CERTIFICATE OF APPROPRIATENESS

Property: 1330 Cortlandt Street, Lot 22, Block 168, Houston Heights Subdivision. The property includes an altered historic 4,301 square foot, two-story wood frame single-family residence and a detached two-story accessory structure situated on a 9,900 square foot (75' x 132') interior lot.

Proposal: Alteration – Revision

Replace the approved six pairs of 8” diameter round columns with six 10” square columns. Install 19 solar panels on the south facing slope of the roof of the approved rear addition and the detached rear accessory structure.

**WEST SIDE ELEVATION**

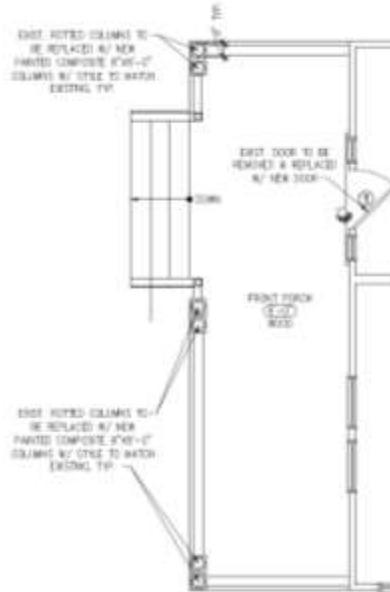
1330 Cortlandt – Question need for square column replacement. No evidence that round columns were not original design. Recommend the applicant review offered 12 inch fiberglass round columns (Tuscan style) manufactured by Fiberglass Specialties Inc., P.O. Box 1340, Henderson, Tx 75653 (903) 657-6522. Don't have a problem with fiberglass replacements.

1330 Cortlandt (columns) — Object — Would become “Support” if evidence surfaced supporting original columns were square

**PROPOSED SOLAR PANELS**  
BIRD'S EYE VIEW

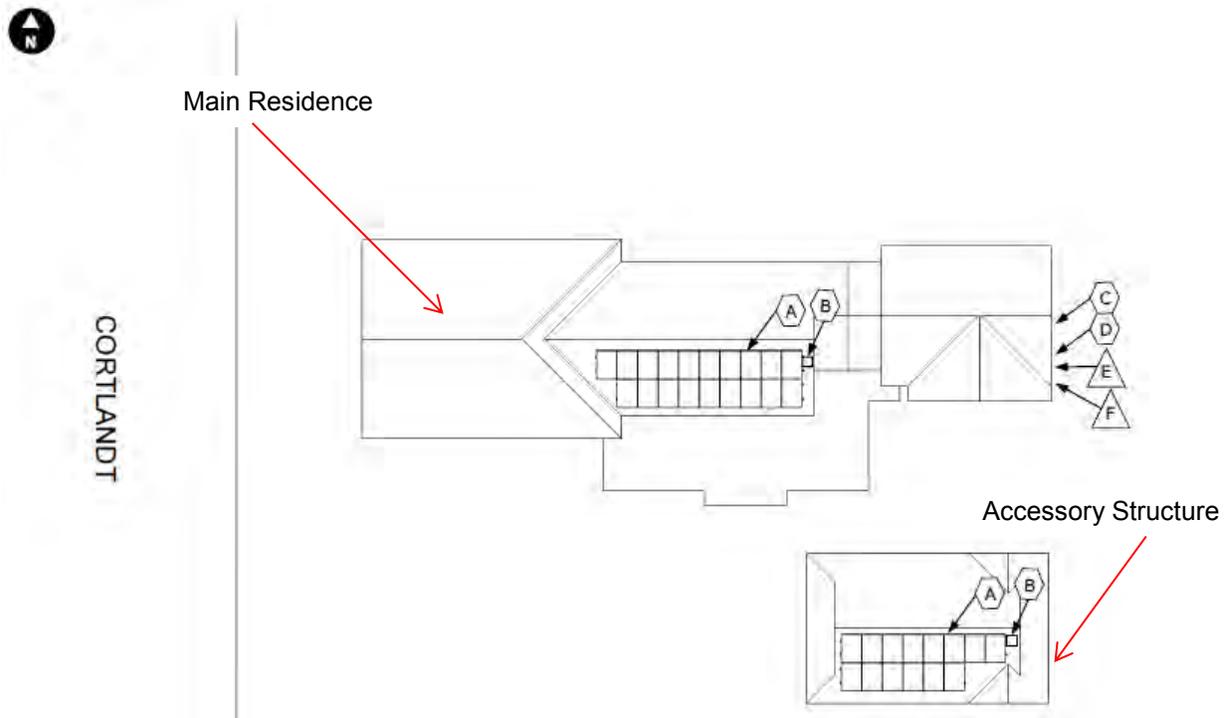
1330 Cortlandt solar panels – no objection when solar panels are placed on the non-contributing portion of the structure
